# CITY OF ALBUQUERQUE

**Re: McDonald's at San Mateo and Academy  
Request for Permanent C.O. - Accepted  
Engineer's Stamp Date 2-9-16 (E18D019C)  
Certification date: 5-27-16**

Project Title: McDonald's San Mateo Building Permit #: T2014-92777 City Drainage #: E18D019C

**Re: McDonald's at San Mateo and Academy (E18D019C)  
Grading Plan (C7.0) Dated 2-9-16  
Post Developed Drainage Plan (C8.1) Dated 2-9-16**

**ACCESSIBLE PARKING SIGN DETAIL**  
 NOT TO SCALE

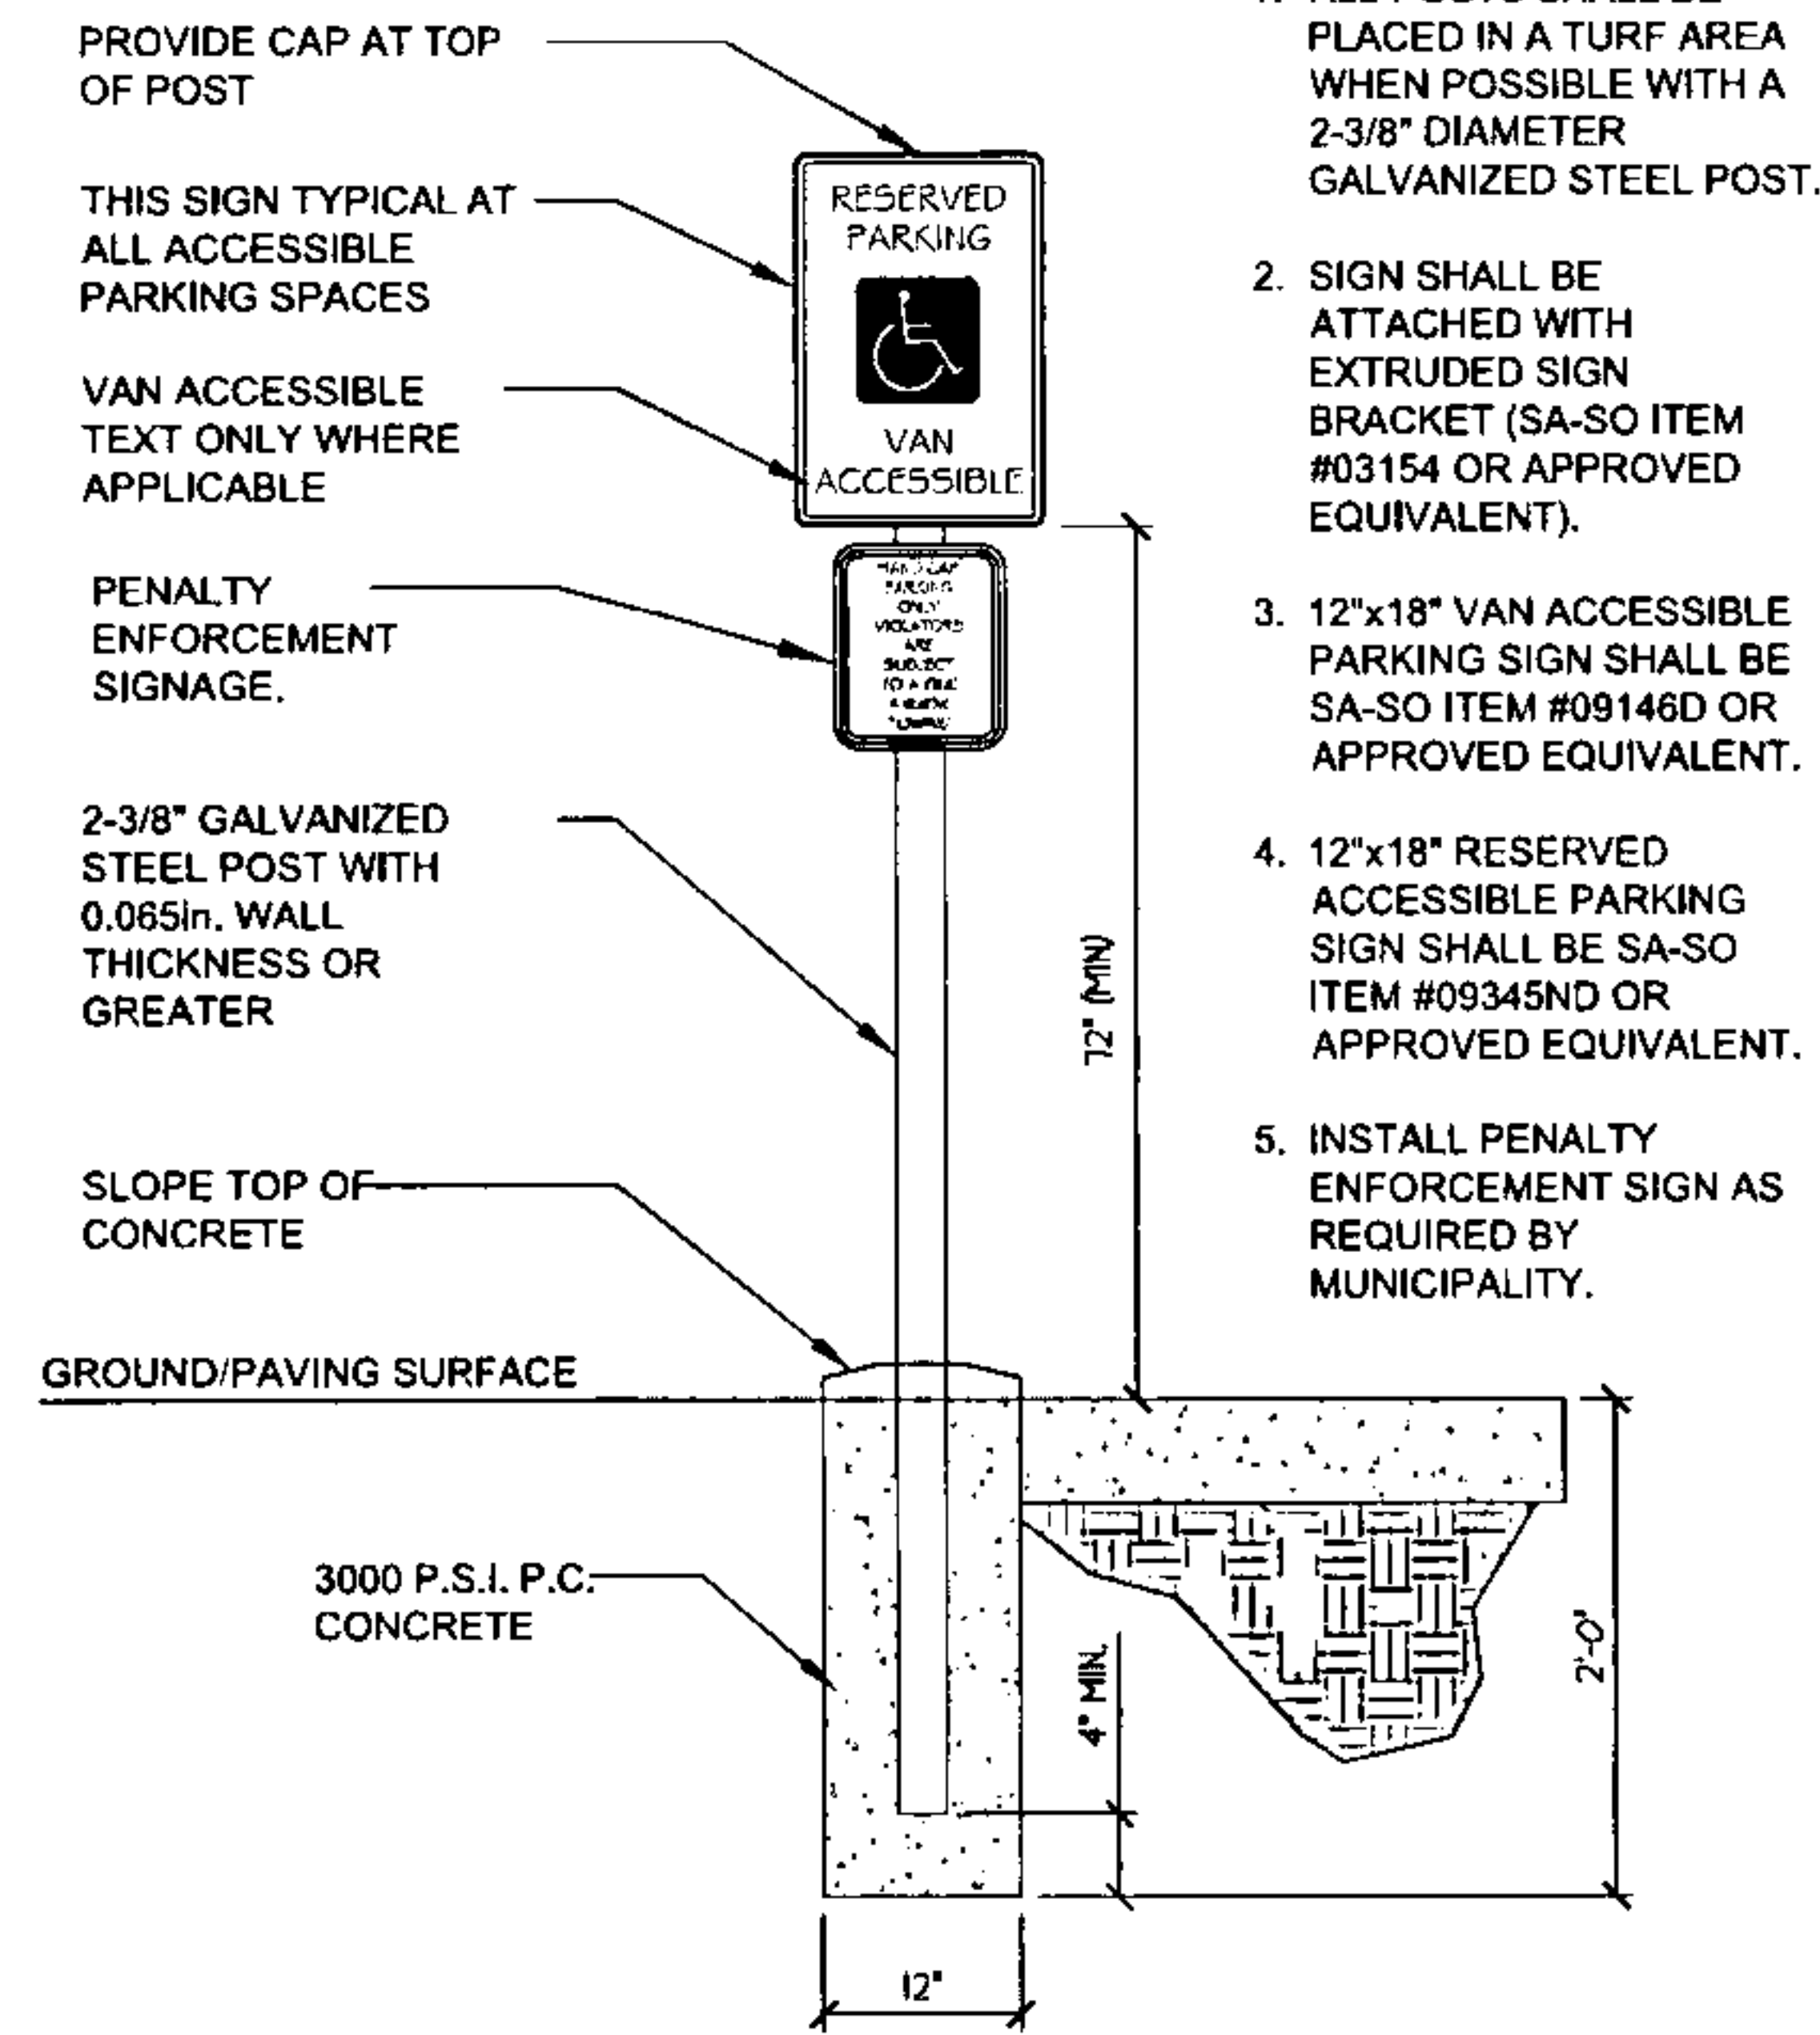
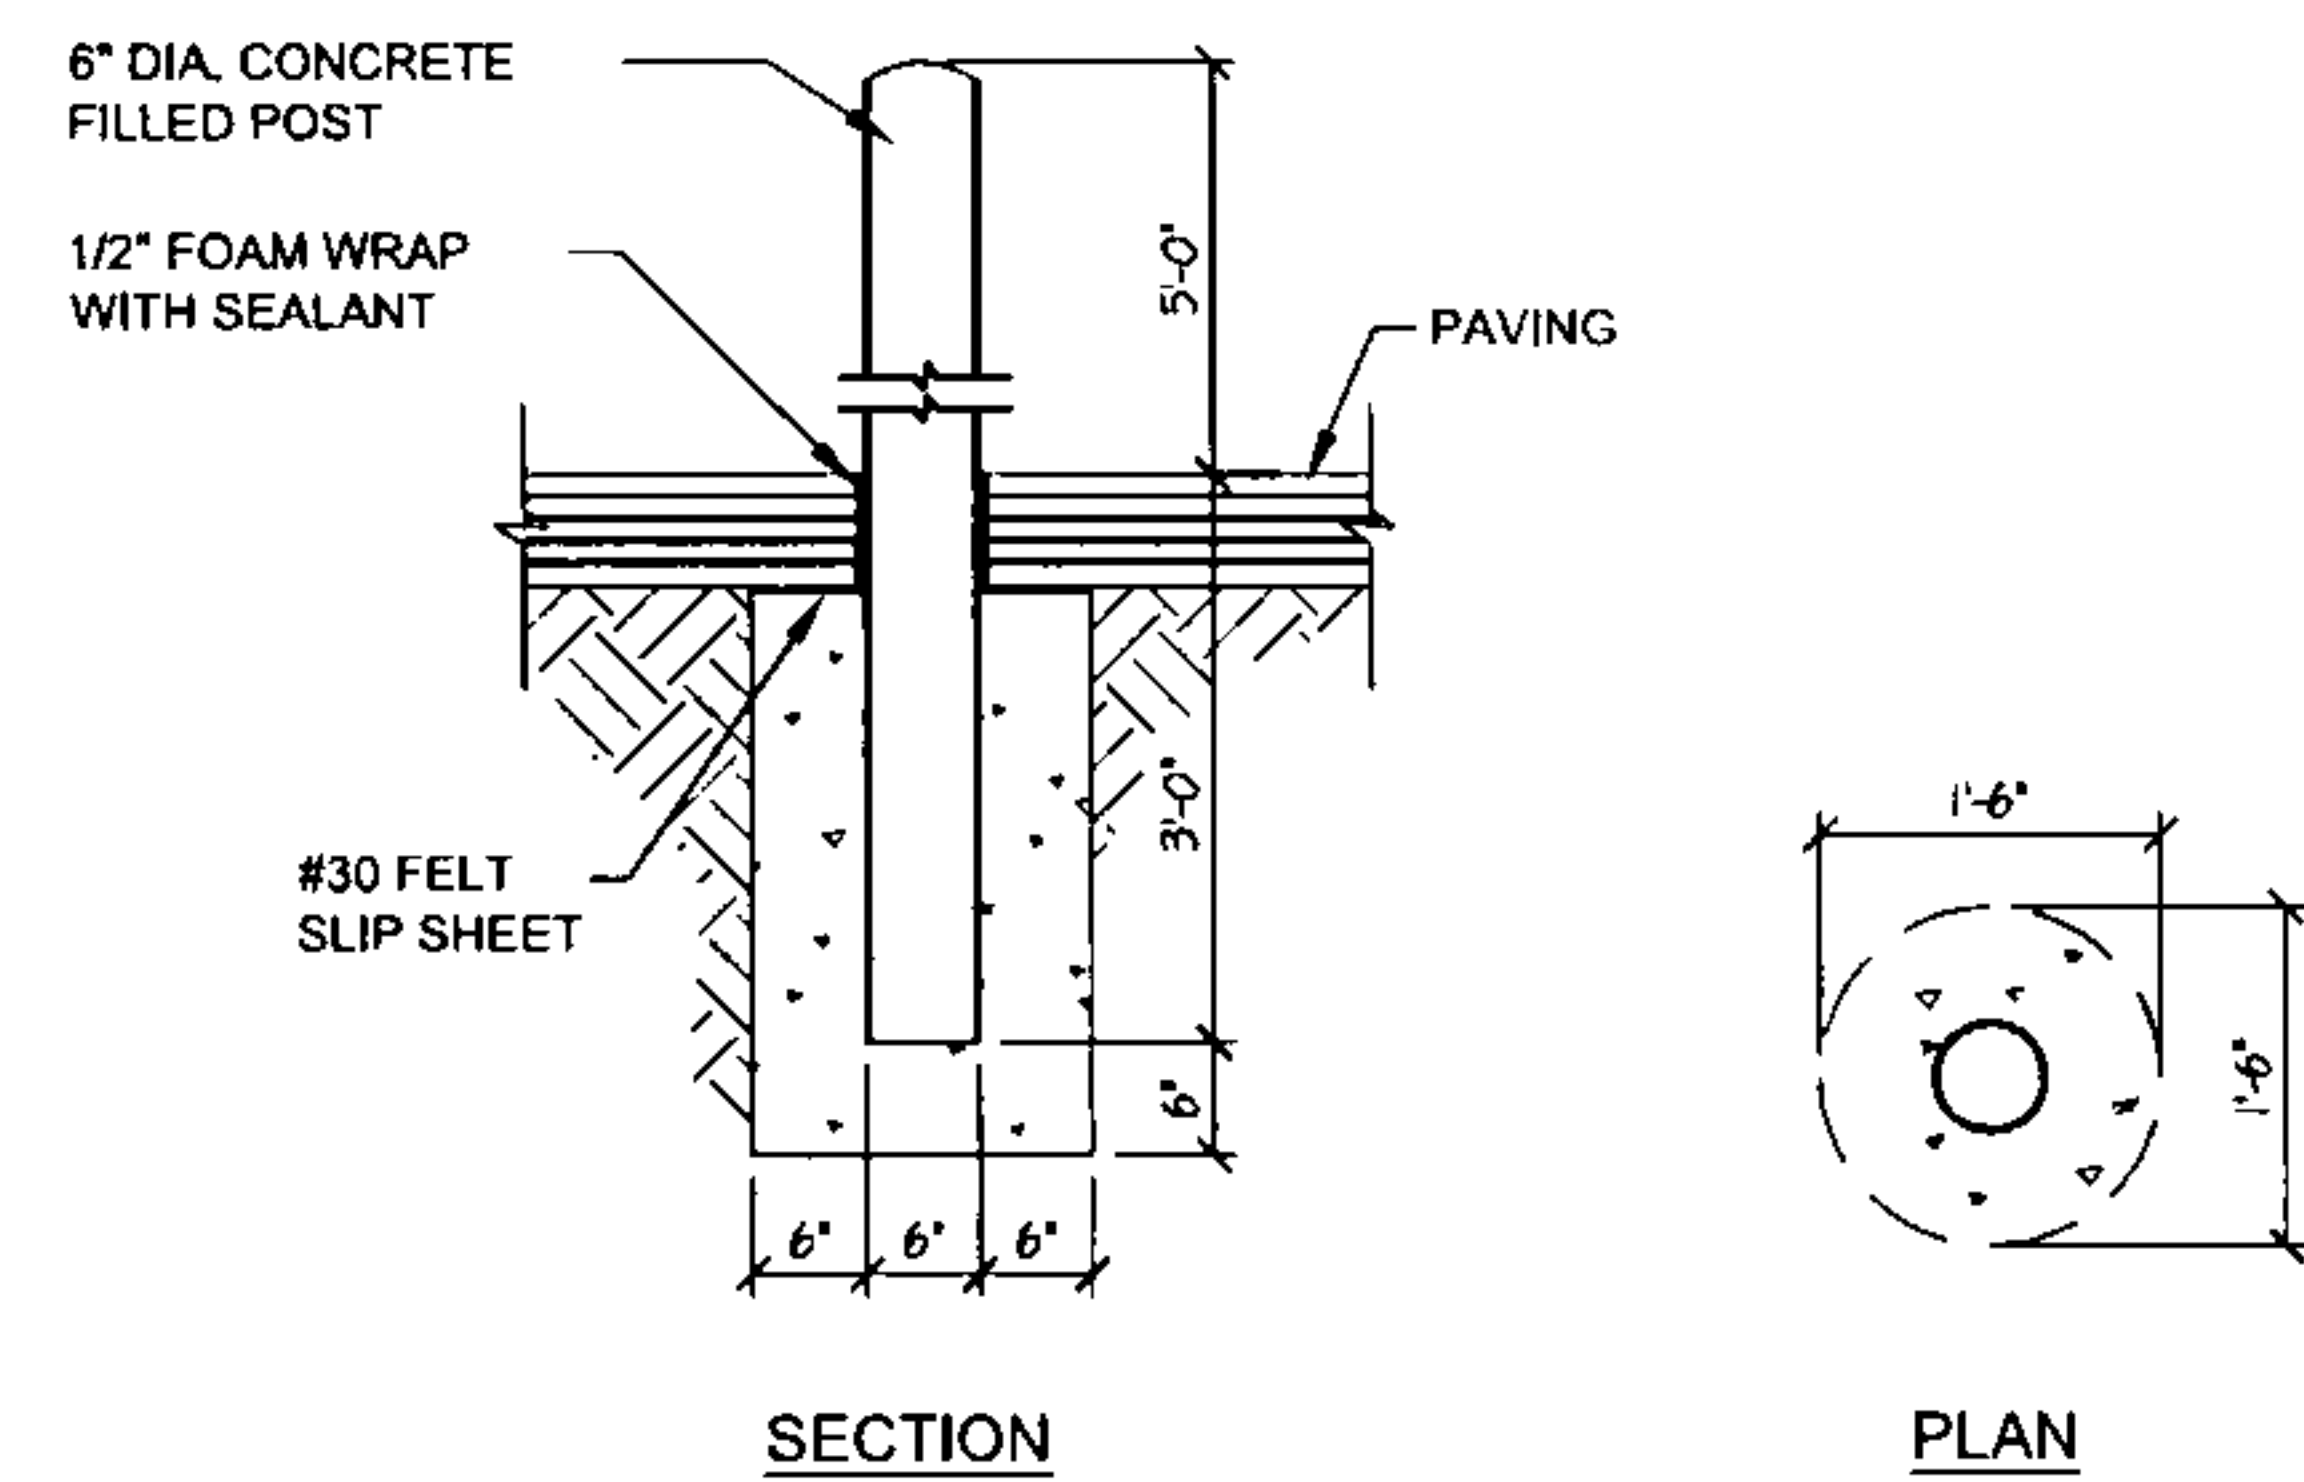
4. Include an ADA van accessible sign. This sign must have the required language per 66-7-352.4C NMSA 1978 **"Violators Are Subject to a Fine and/or Towing."** (Provide sign detail on Sheet C10.1 as called out by Keyed Note 7 on the plan sheet.)
